**CITY COUNCIL  
REGULAR MEETING AND  
WORKSHOP AGENDA**

**NOTICE OF REGULAR MEETING AND  
WORKSHOP OF THE CITY COUNCIL OF  
THE CITY OF HARKER HEIGHTS, TEXAS**

1. Discuss and consider approving a request for Preliminary Plat approval for the subdivision referred to as Stone Lake Trails, on property described as a certain tract Page 2 of 3 of land located in the John Hughes Survey, A-379, located in Bell County, Texas; subject tract being all of the following:
  1. A called "28.68 Acres" conveyed in a Warranty deed from Monica Martin, et al to Emmons General Investments, LTD dated 6-19-2018 and recorded in Document No. 2018-00025884 of the Official Public Records of Bell County (OPRBC)

# PRELIMINARY PLAT OF: STONE LAKE TRAILS F.M. 2410, Bell County Rural, Texas

06/16/21  
SCALE: 1"=100'  
DRAWN: RR  
ELEC. DRAWING FILE  
C:\18005-UP.DWG  
DATE: 06/16/21  
JOB NO.: 18005  
06 OF 10  
**C2.0**

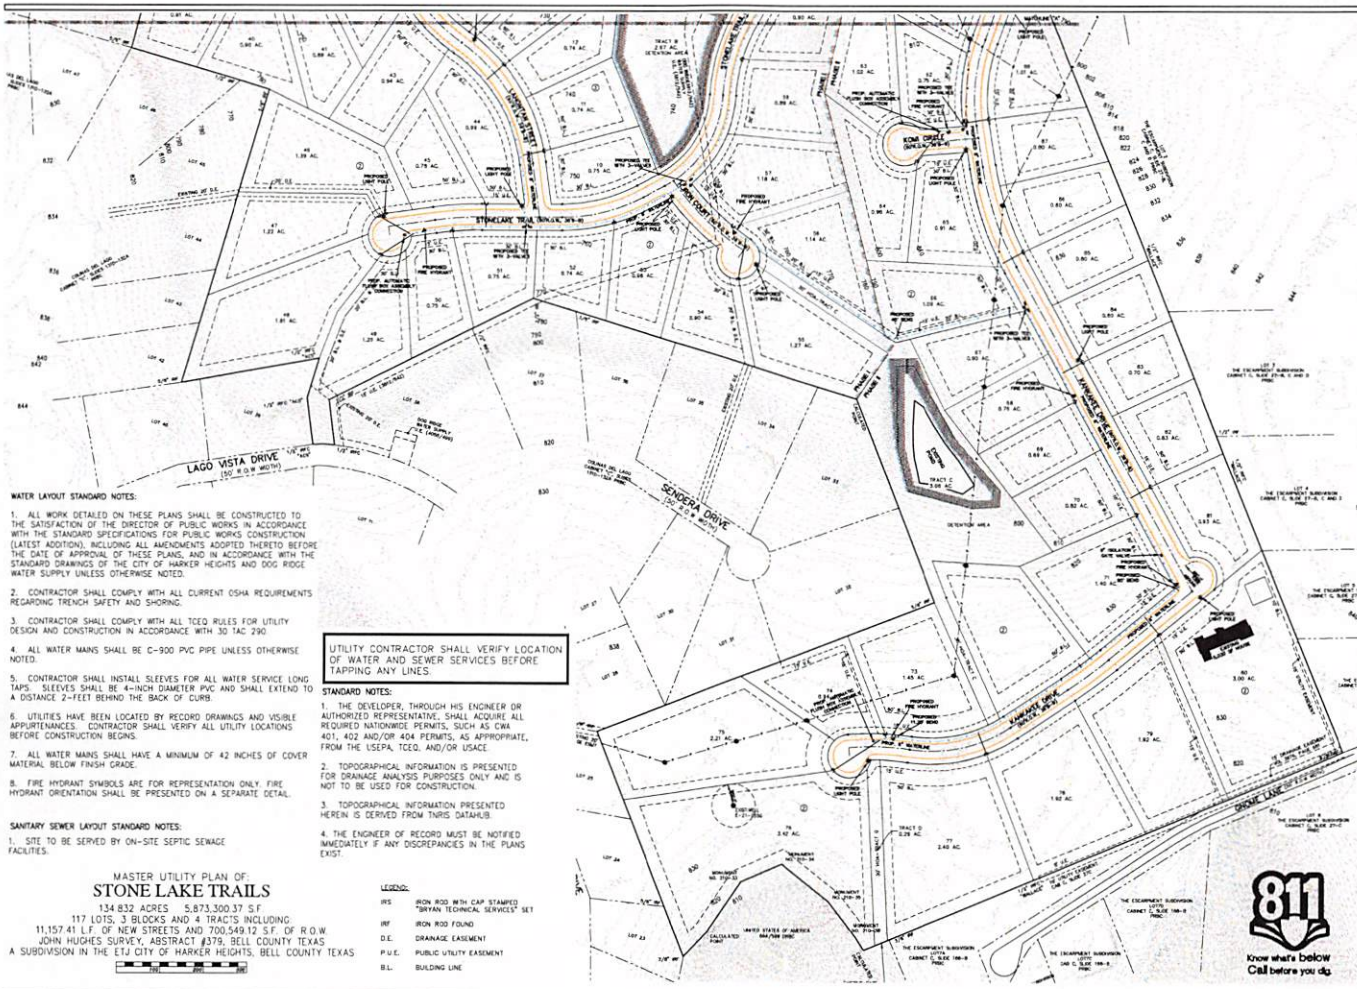
1. This preliminary "Master Utility Plan" does not address the fact that Dog Ridge Water Supply Corporation has a four inch water line originating at an existing Central Texas Water Meter Supply meter vault shown on Sheet C2.0 (Block 1, Lot 7) and going access the plotted

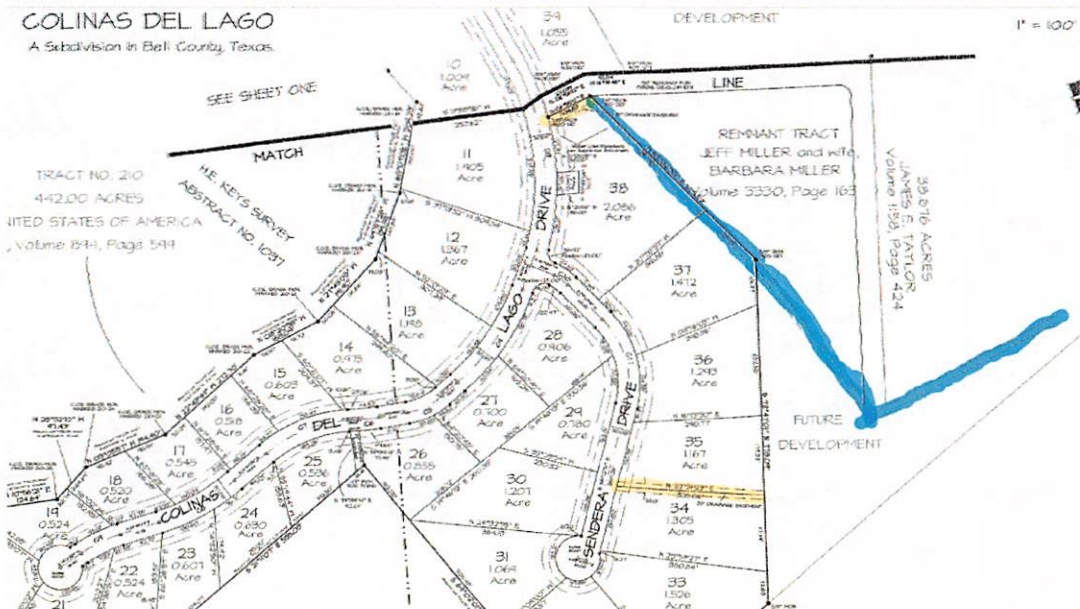
### Planning & Development, Kristina Ramirez & Yvonne Spell

1. Applicant is advised that a concept plan submission is required prior to or with submission of a preliminary plat per §154.20(A)(2)(e). **6/17/21 Not Met. Applicant's response is noted. However, a Concept Plan application was not submitted with the revisions.**

2. Applicant shall provide a detail with typical building placements and building envelopes. **6/17/21 Partially Met. Applicant's response is noted. However, applicant shall amend Surveyor's note #12 such that it is clear that those are the current setbacks at the time of platting and that setbacks are determined by the adopted zoning district as mended by City Council.**

3. Applicant shall provide half of the lacking right of way to meet the 120' required width along those lots that abut FM 2410 (major arterial). **6/17/21 Partially Met. The right of way dedication being offered with this platting action must be reflected on sheet 1 or a note added to refer to Sheets 2-4 for additional detail.**

7. Applicant shall clarify the sheet and phase linework such that they are discernable in black & white and when reproduced (different line types). **6/17/21 Met.**

8. On page 1 of the plat dedication pages, applicant shall provide uniform annotation for all surrounding parcels (lot/block information, subdivision name, type of use for a distance of

300 ft from the plat boundary). 6/17/21 Not Met. The following clarification is provided per the applicant's request. One Sheet 1 some parcels that are adjacent to this development are labeled by lots and blocks (The Escarpment Subdivision; Lakeside Hills Subdivision), while others are only identified by the subdivision name (Colinas Del Lago). Additionally, code requires that the usage of the lots within 300 feet of the property boundary be identified. If they are all the same use then that can be added in a note on Sheet 1.

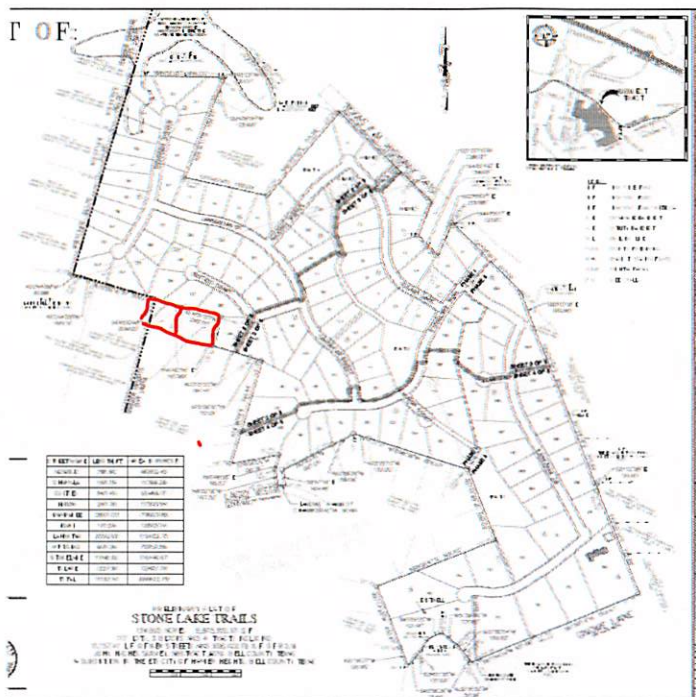
9. Applicant shall illustrate the adjacent offsite and onsite existing 20' drainage easement and address connectivity of said easement (Lots 49-56, Block 2, & Tract C). This point discharge shall be taken into account in the drainage analysis. 06/17/21 Partially Met. The applicant shall illustrate and annotate all drainage easements (yellow) that continue onto this property and ensure that the existing 15' waterline easement by separate instrument (blue highlight) is shown in the proposed subdivision. Applicant shall provide a copy of the water line easement recorded by separate instrument. Applicant shall verify if there are natural swales or low spots in the existing drainage easement and address how the flow will be conveyed from those locations to the proposed Drainage Tract C and not into a proposed home.

10. Applicant shall illustrate the adjacent offsite 10' public utility easement and address connectivity of said easement (Lots 77-80, Block 2). 6/17/21 Partially Met. Since a minimum 15' easement is required Applicant shall provide a 5' rear lot utility easement for the above listed lots. Additionally, see response from the Public Works Director in his comment #4.
11. On all plat dedication pages, the applicant shall identify usage and ownership for all Tracts (A, B, C & D) in a uniform manner (i.e. each have Tract name and acreage with a note for usage and ownership on the dedication page). 6/17/21 Partially Met. In order to avoid the potential

for conflicting interpretations in the future, please annotate the Tracts in the same manner on all 5 plat dedication sheets. Additionally, All tracts used for drainage purposes can have a minimum 15' right of way frontage. However, Tract D needs to be wide enough to accommodate the existing gate opening and be not less than 30' per §154.42(C)(1).

**Sidewalk Layout**

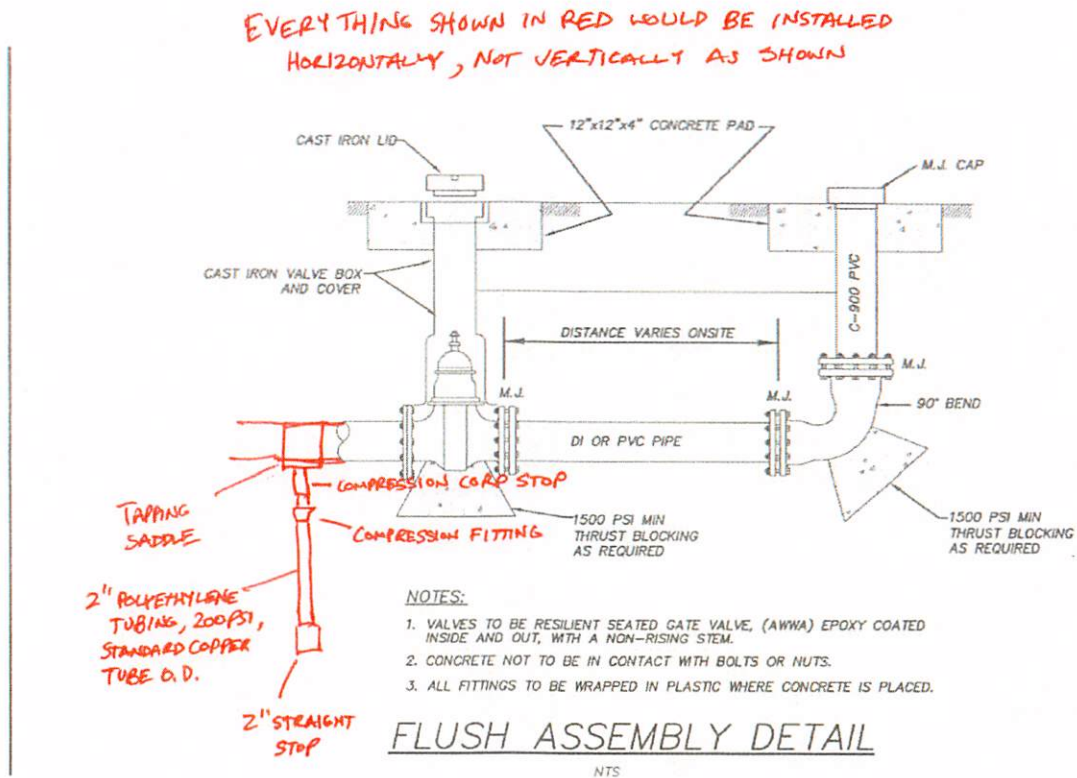
1. Sidewalks are required on both sides of the streets within the subdivision.

**6/17/2021 Sidewalk Layout**
